2020-07 BAR Decision for 518 17th Street NW

BAR 20-07-04

518 17th Street NW

Replace slate roof

Internal gutters,
painted downspouts

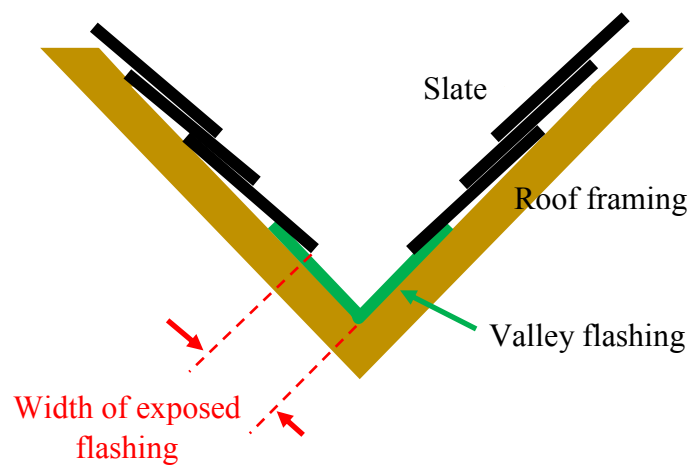
- Match the existing dimensions of the exposed valley flashing.
- Ridge and hip cap profile to match or be similar to the existing profiled, metal cap.
- Install new downspouts at same locations as the existing.

Note cap and valley flashing.

- Match the existing dimensions of the exposed valley flashing.
- Ridge and hip cap profile to match or be similar to the existing profiled, metal cap.
- Install new downspouts at same locations as the existing.
